Dear Referee,

thank you very much for taking the time to review our manuscript. We appreciate the effort you put into reading our preprint and providing constructive comments. Your feedback and suggestions are very valuable to us to improve the quality of our manuscript and our research. We are taking your comments seriously and will address each one of them comprehensively in our revised manuscript. We will especially try to emphasize the motivation and impact of our study and results. In the following we will address each of your comment with a reply and our planned action. If you have any additional insights or suggestions that you believe would further improve our research, please do not hesitate to share them with us. We look forward to sharing our revised manuscript with you soon.

10. *Figure 2.*

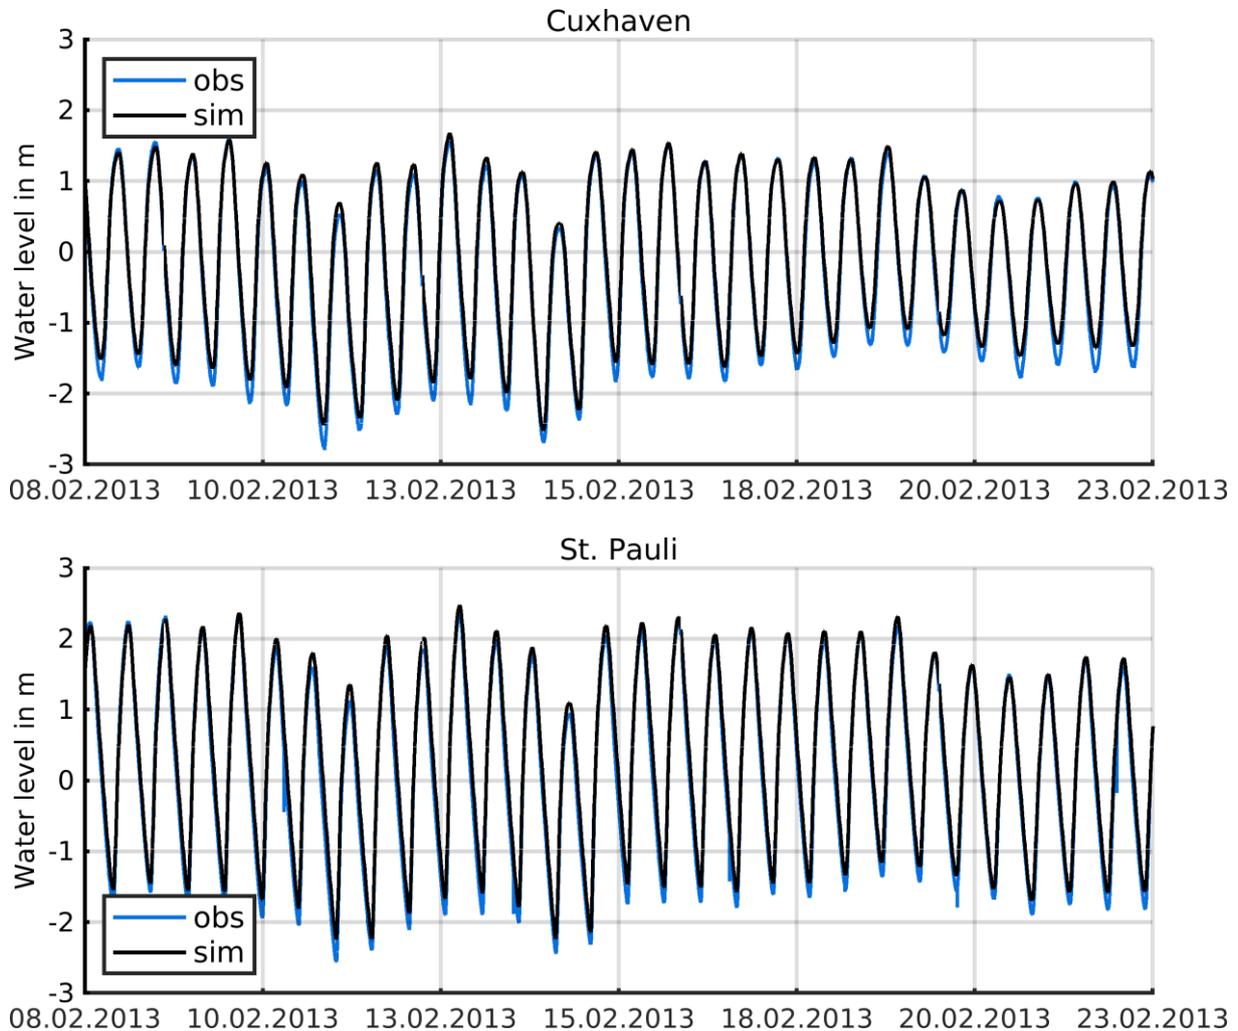
Why are only three days shown here? Why isn't a whole spring-neap cycle shown? Is the performance of the model better/worse during different phases of the spring-neap cycle? Even though you mention that the validation of the model is presented in another paper, it also wouldn't hurt to briefly describe the model quality here in terms of selected parameters (e.g., what is the mean RMSE across all tide gauges in the model domain).

Reply: We decided to show only three days, because the differences in the shape of the curves would not be clearly visible otherwise. However, as you mentioned, it could be of interest to see an entire spring-neap-cycle and possible variations in the performance. Therefore, we will add two figures of an entire spring-neap cycle in the appendix. We will also add

information about the mean RMSE, BIAS and a skill-score after Willmott et al. (1985) of 39 tide gauges in the model domain.

Action:

Figures of an entire spring-neap cycle will be added to the appendix.

We will add the following sentence after LL156:

“A similar display for an entire spring-neap-cycle can be found in the appendix. It shows no distinctive differences in the performance during different phases of the displayed spring-neap cycle.”
